SUBJECT/PROJECT: RESOLVE VARIOUS SITE PLANNING ISSUES THAT

STREET IMPROVEMENTS FOR 21 ½ ROAD AND H ROAD

# Exhibit A Comment Response Letter Depter Date: January 11,2004

File #SPR-2003-050

# Cost Estimate for ½ Street Improvements for Monument Truck Nov 22, 2003

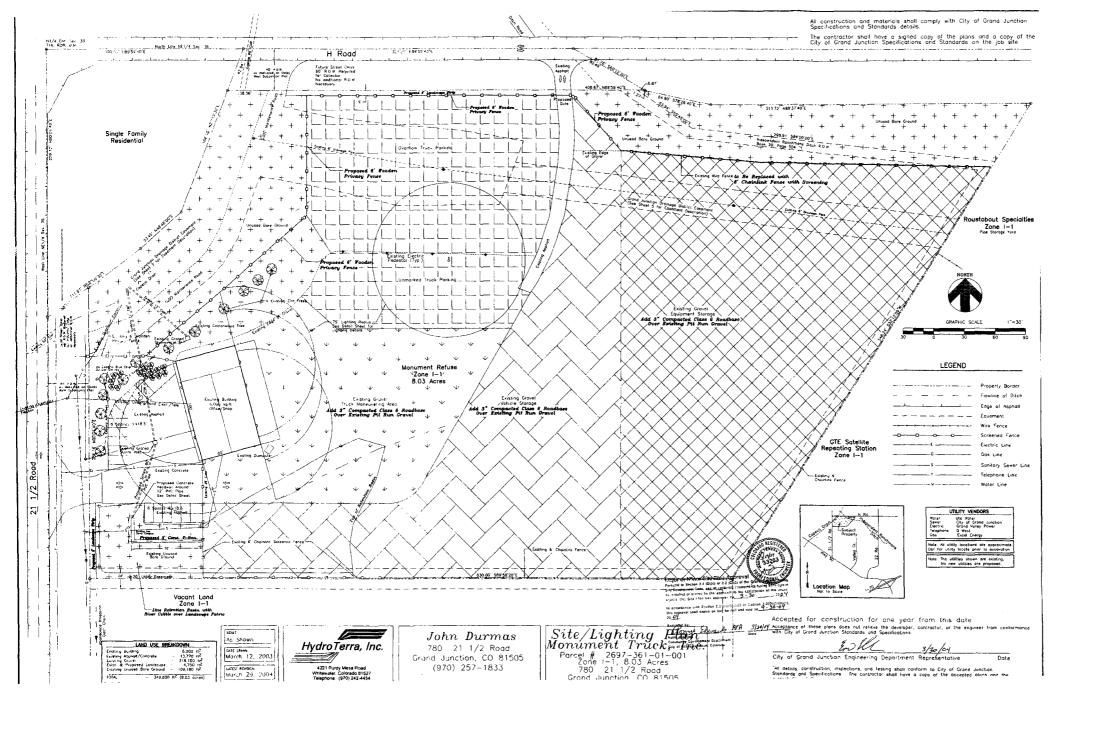
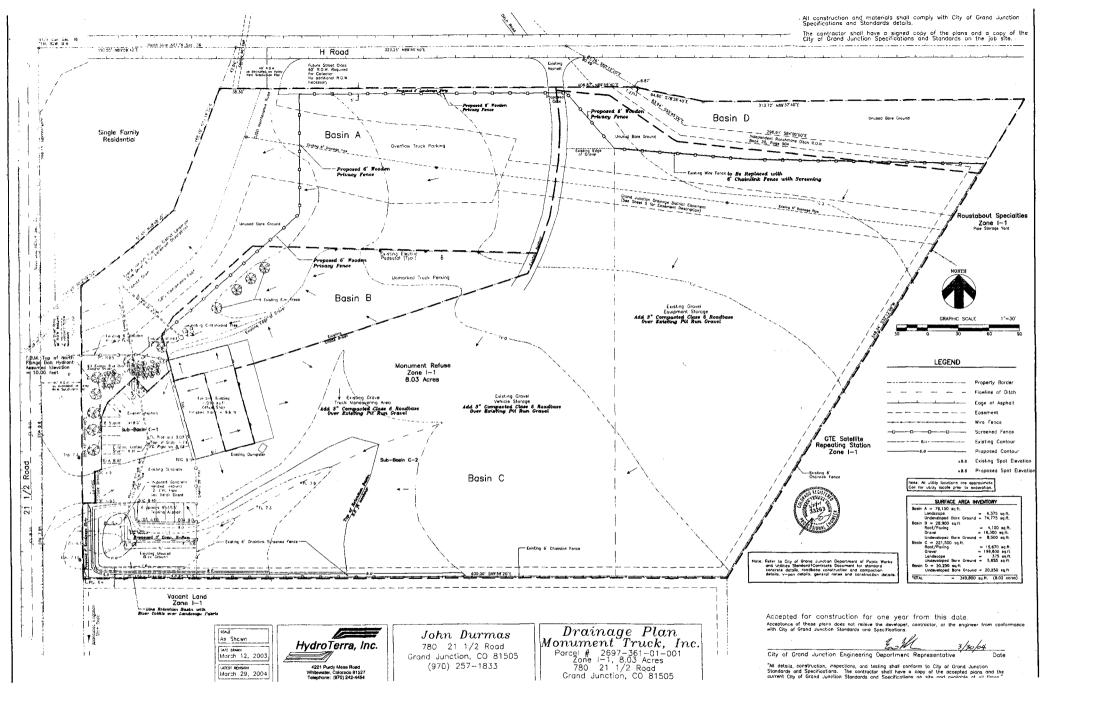
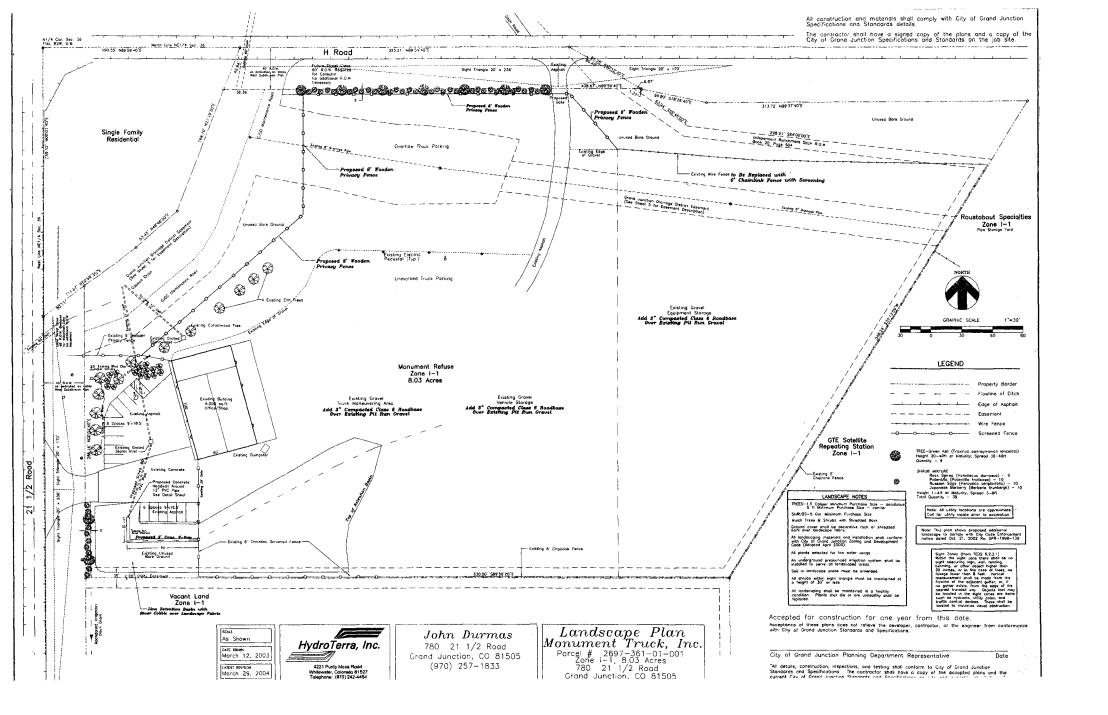
21 ½ Road improvements consisting of ½ street section (curb, gutter, and additional asphalt mat bringing total ½ street asphalt width to 18 ft) will be constructed by the owners. No H road improvements will be built. Payment of ½ the estimated amount to construct the ½ street improvements (curb, gutter, and additional asphalt mat bringing total ½ street asphalt width to 18 ft) will be made by owners per an agreement negotiated with the City Attorney. A geotech report and plan

1/2 of est. H Road Improvements = 16,450.00

This is the number for H Road
to put in agreement w/City
